CalPA Data Request 20.1

The following questions relate to your 2022 WMP Update resubmission (page citations refer to the clean, revised version, dated July 15, 2022).

Response to CalPA Data Request 20.1

Figure 3: Map of Mt. Shasta Underground project identified to date with ZOP IDs.

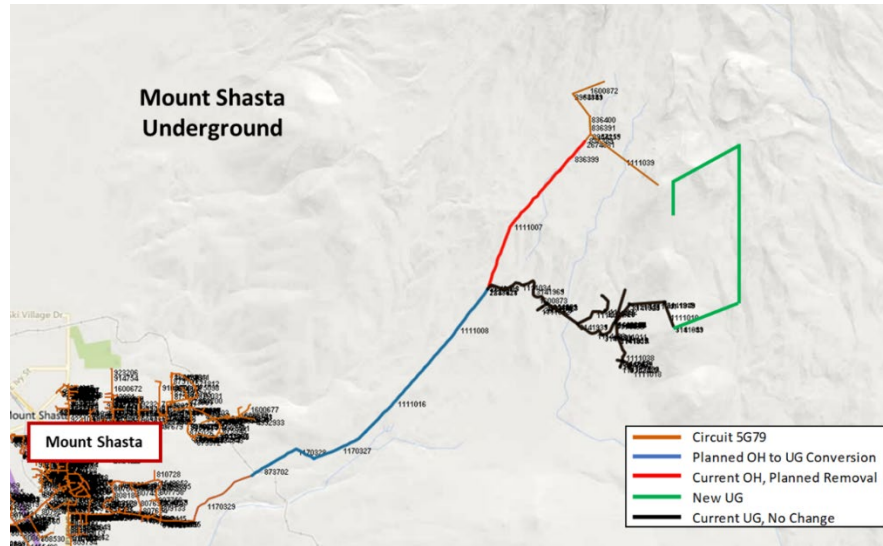
Please provide the following information about each of the potential undergrounding projects for which “PacifiCorp has completed the engineering design phase”.

- (a) Circuit name.
- (b) Circuit-segment (i.e., zone of protection) ID number.
- (c) Circuit voltage.
- (d) HFTD tier of the portion of the circuit that would be undergrounded in the potential project.

- (a) 5G45/5G83 and 5G79
- (b) PacifiCorp has provided the ZOP ID # in Figure 3 and Figure 4 below. It is important to note that some zone of protections will be broken up into more zone of protections

while some new underground lines will be new zones of protections, no ID # are assigned for these new segments yet:

ZOP ID List of highlighted project area:

873702, 1170329, 1170328, 1170327, 1111016, 1111008, 2833328, 7248411, 1111017, 2675705, 1111034, 3141963, 3141965, 1600873, 3141959, 2954525, 1111015, 2954521, 2954523, 1111012, 3141961, 1111013, 3141931, 3141933, 3141935, 1114463, 3141937, 3141939, 1114465, 3141943, 3141945, 1114466, 3142439, 3142441, 1561067, 3142443, 1111011, 3141957, 3141953, 1111038, 3142437, 3142431, 1111037, 3142433, 1111036, 1111035, 3142435, 1111009, 3142429, 3142427, 1111018, 3141955, 1111014, 3141947, 1114467, 3142445, 3142447, 1111043, 3142449, 1600874, 3141921, 3141919, 1111042, 3141923, 1111041, 3141917, 3141913, 1111010, 3141951, 3141949, 1111033, 3141915, 1111040, 3141941, 1114464, 7248413, 1111007, 836399, 2674881, 1114461, 3141927, 3141925, 1114460, 3141929, 1114462, 836389, 2954155, 2954153, 836391, 836387, 2954151, 2954149, 1600872, 836400, 6247219, 1111039

Figure 2: Map of Underground projects identified to date.

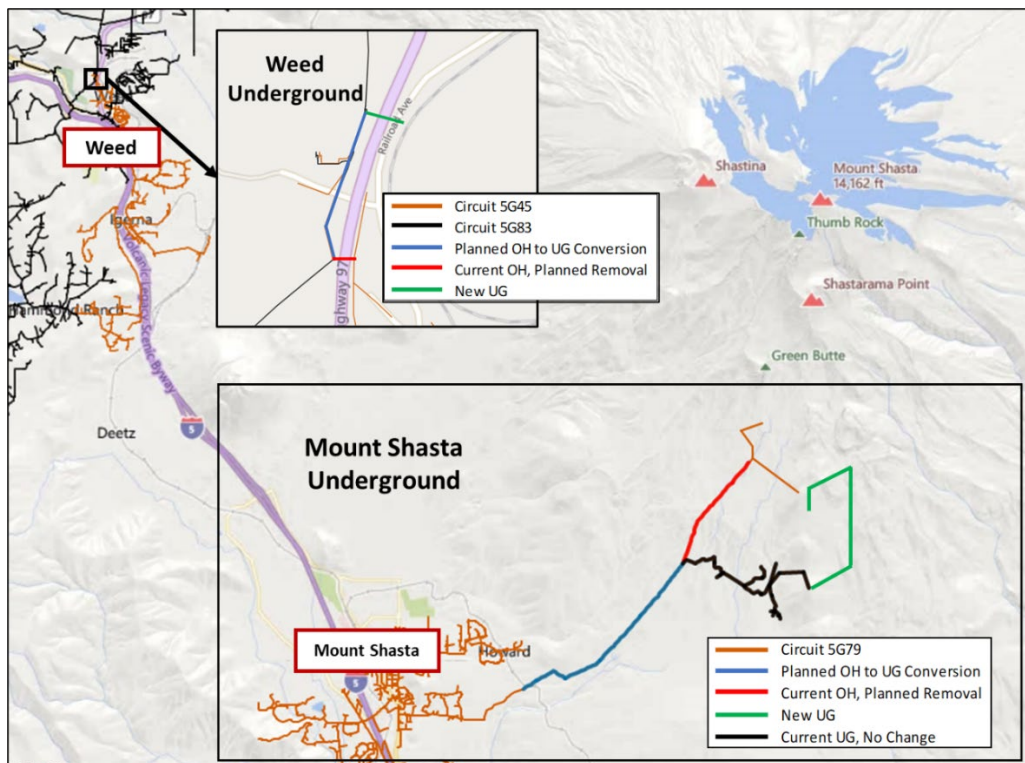
- (c) Please identify a potential project that PacifiCorp has evaluated to date, where PacifiCorp estimated unit costs close to \$1 million per line mile.

- (d) Please describe the characteristics of the project identified in subpart (c) that contributed to the relatively low unit costs.
- (e) Please identify a potential project that PacifiCorp has evaluated to date, where PacifiCorp estimated unit costs close to \$6 million per line mile.

- (b) PacifiCorp did not prepare formal work papers and / or perform analysis for these estimates, however, PacifiCorp did review the California Public Utilities Commission provided estimates from the IOUs, as shown in Figure 1 above.
- (c) Please refer to the Mt. Shasta underground project on circuit 5G79 provided in Figure 2 below:

- (d) The characteristics of this project which contributed to the relatively low cost units are:
- Geology – no wetland or heavy rock.
 - Cultural surveying – previously completed along route.

- Cultural monitoring services (if needed) – based on survey, not needed.
 - Environmental surveys – little to no vegetation.
 - Environmental monitoring services (if needed) – not expected.

- Environmental offsetting activities (if needed) – not expected.
 - Permitting – United States Forest Service (USFS) preferred route.
 - Significant vegetation work – little to no vegetation, it's in a ski lift/roadway cleared area.

- Existing ROW – granted by ski resort and USFS.
 - Other utility facilities, and – no other utilities on this route.
 - Customer density – two customers along route; therefore two connections needed (very little).
